NAME DEFLECTOR CLAMP PLATE			
DRAWN AWR	CHECKED	DATE 10-26-93	SCALE FULL
MATERIAL		356-T6 CAST ALUMINUM

OWENS-BROCKWAY
GLASS CONTAINERS, a unit of Owens-Illinois, 
DRAWING NUMBER
OIS-108-1794

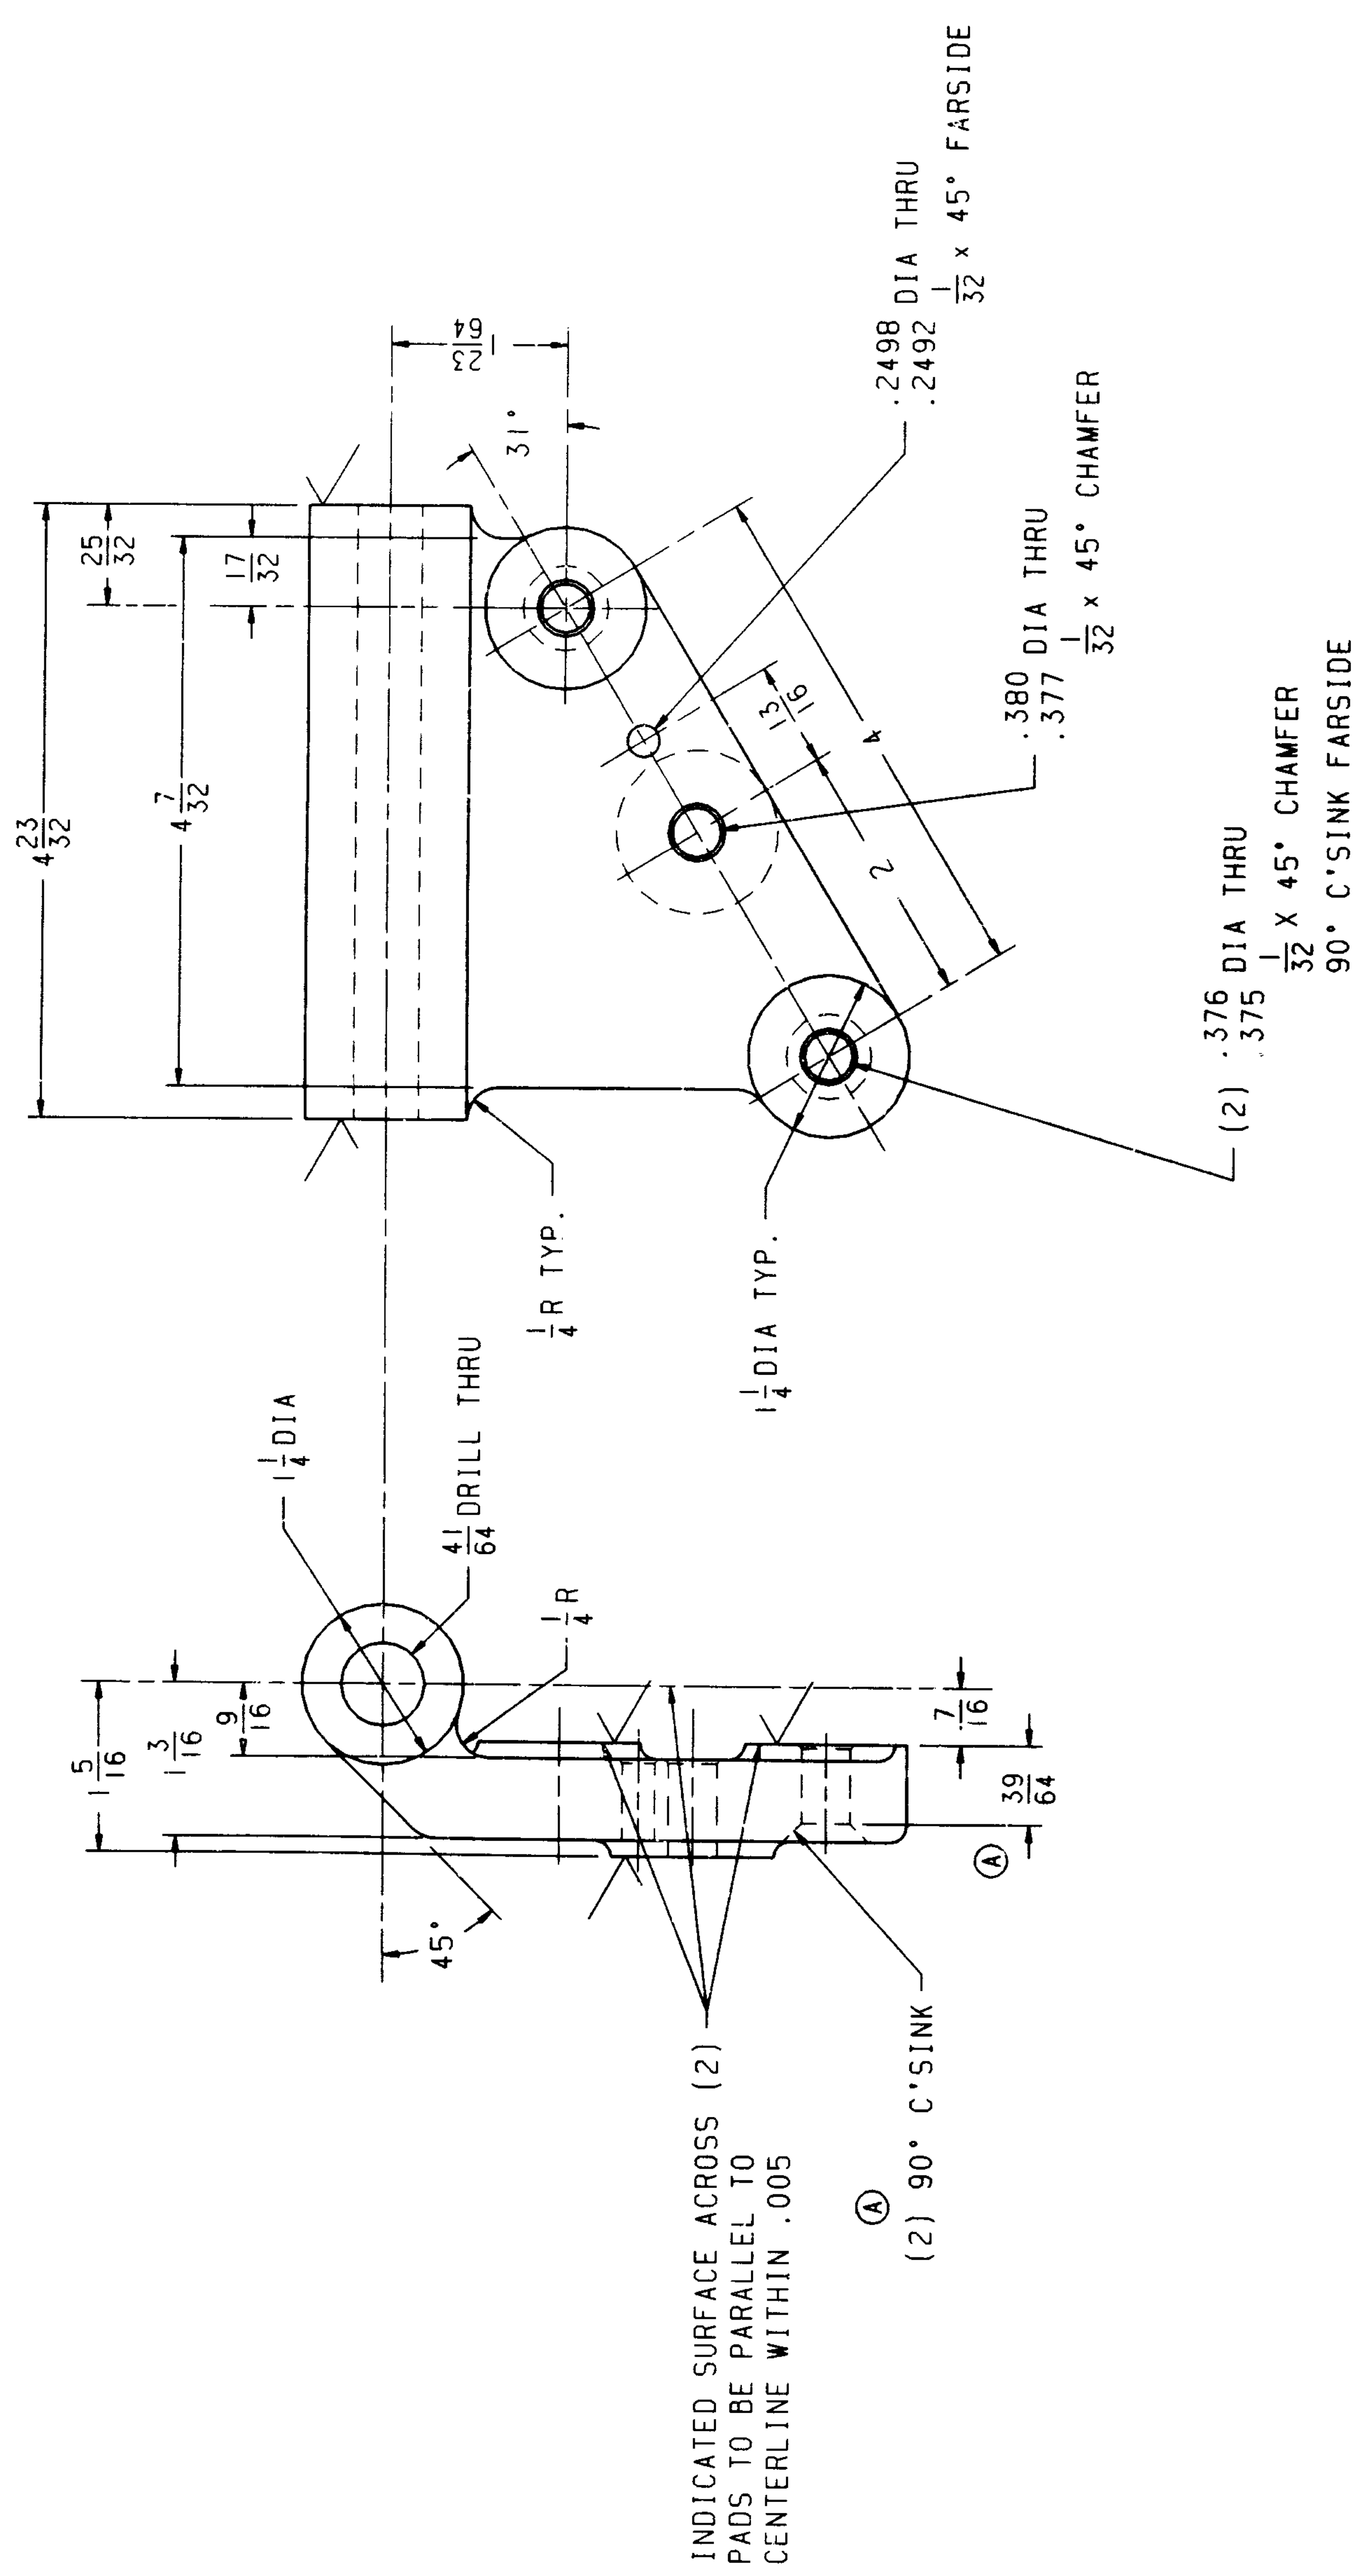
NUMBER	01S-108-1794	CHANGE	A	CHANGED	AWR
BY	LETTER				
CHANGE DESCRIPTION & REASON: (2) 1/32 x .45" CHAMFER REPLACED BY 90° C.SINK @ 39/64					
TYPE	1 - PATTERN 2 - MATERIAL 3 - DIMENSION 4 - FINISH 5 - CORRECTION 6 - PARTS 7 - COMBINATION 8 - OTHER	EFFECTIVITY	7 - NEXT MANUFACTURED LOT 8 - IN PROCESS 9 - UNASSEMBLED PARTS - IN PROCESS 10 - STORES IN ASSEMBLY FLOOR 11 - PARTS IN ASSEMBLIES 12 - PARTS OR ASSEMBLIES IN MACHINES 13 - SPECIAL INSTRUCTIONS 14 - FOR HARD PARTS, MACHINE NO.'S, ETC. 15 - RECORD ONLY		
GLASS CONTAINERS, A UNIT OF OWENS-ILLINOIS		FRAME NO.			
OWENS-BROCKWAY		CODE			
01		5 4 3 2 1
